Erection Plan for Precast Concrete NEXT BEAMS
Rochester, VT
ER BRF 0162(17)
Bridge 16

July 21, 2014

SHOP DRAWING REVIEW

TOWN OF ROCHESTER
VT ROUTE 73 (RURAL MAJOR COLLECTOR)
BRIDGE NO.: 16 PROJECT NO.: BRF 0162 (17)

TYPICAL LIFTING AND HANDING DETAIL
SCALE: 1" =1'-0"
NOTE: OTHER REINF. NOT SHOWN FOR CLARITY.

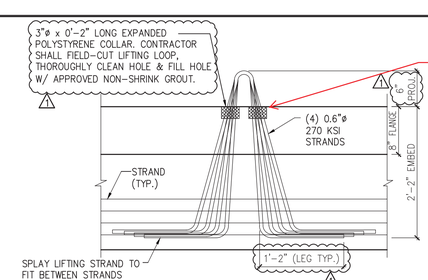
Revise as required per contract plans for clear cover, per A/NB1. Add note that states field cut point to match clear cover. Add note to specify epoxy paint cut ends.

D NB1 REINFORCING @ CURB
OTHER BEAM REINF. NOT SHOWN FOR CLARITY 3/4" =1'-0"

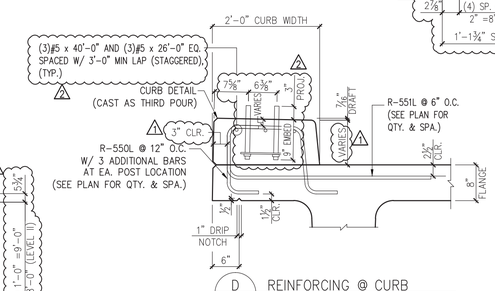
Confirm quantity include extra 3 at each post location, per D/NB1

Verify quantity with D/NB1

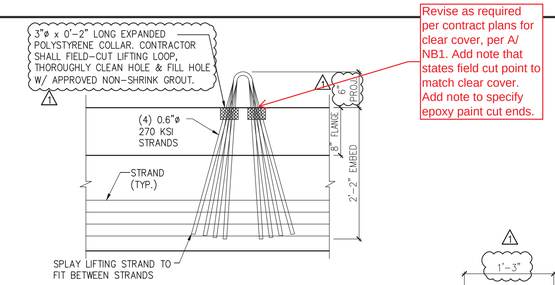
Revise as required per contract plans for clear cover, per A/NB1. Add note that states field cut point to match clear cover. Add note to specify epoxy paint cut ends.

TYPICAL LIFTING AND HANDING DETAIL
SCALE: 1" =1'-0"
NOTE: OTHER REINF. NOT SHOWN FOR CLARITY.

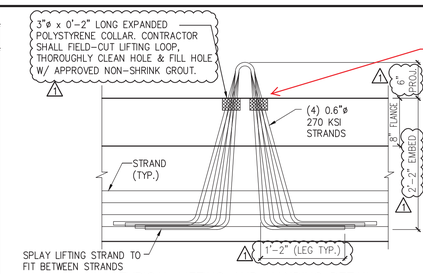
Revise as required per contract plans for clear cover, per A/NB1. Add note that states field cut point to match clear cover. Add note to specify epoxy paint cut ends.

D NB5 REINFORCING @ CURB
OTHER BEAM REINF. NOT SHOWN FOR CLARITY
3/4" =1'-0"

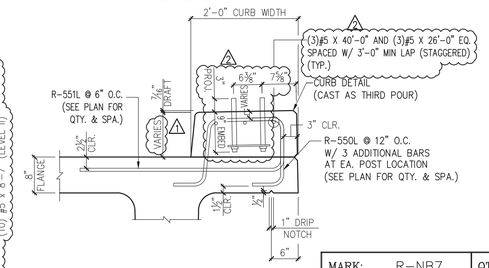
Revise accordingly
